Delegated Report

Planning Application No: 20240981

Location: 133 St Marks Avenue Northfleet Gravesend Kent

Description: Creation of a vehicle crossover and a driveway.

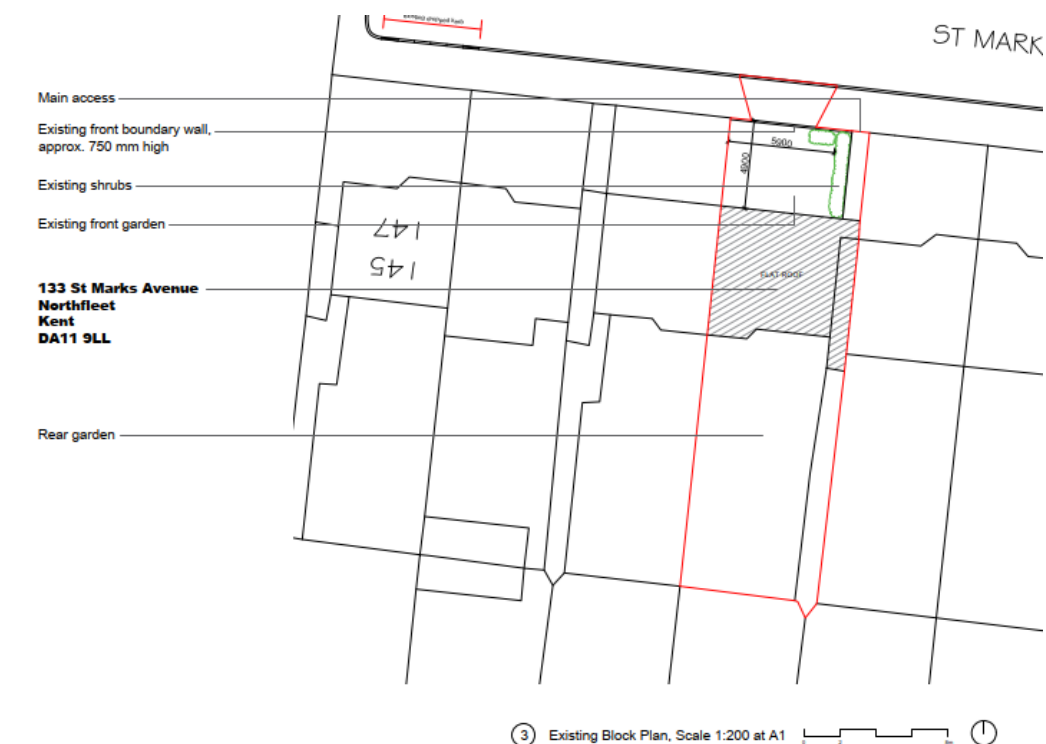
The plans show the existing dwarf wall would be removed and the existing soft landscaping would be reduced, in order to create space for the development.

Although it is regrettable that some soft landscaping would be lost as a result of the development, the proposed plans do show an existing shrub/hedge is to be retained, which is desirable. According to the details included with the application, the driveway would be constructed using a tarmac surface, connected to a drainage system that directs surface water to a soakaway located beneath the driveway. Although outside of the planning remit, it should be noted that building regulations do not permit soakaways within 5 metres of a building and/or highway. Therefore, the driveway shall need to be permeable to ensure adequate drainage is provided, which can be secured by condition if permission were to be forthcoming. Overall, the proposal is not considered to detrimentally impact the character and appearance of the main building, or surrounding area.

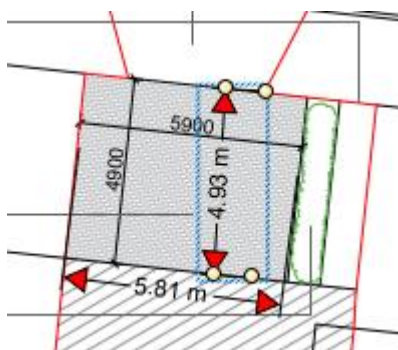
SPG 4 - KCC Parking Standards (2006) and Gravesham's Householder Extensions/Alterations Design Guide (2021) state that car parking spaces need to be a minimum of 2.50m wide (2.7m where spaces adjoin an enclosed boundary) and 5.00m deep. The plans show that the hardstanding area would fall slightly below the depth requirement:

However, on balance, this shortfall is considered minimum. If permission were to be forthcoming, an informative could be added to the decision notice to highlight that cars should not overhang the highway (pavement). The plans show the development would provide sufficient parking area for two cars. Although visibility splays have not been shown on the plans, the soft landscaping would be limited to 600mm in height, so it is considered that there would be an acceptable level of visibility in the interests of highway safety.
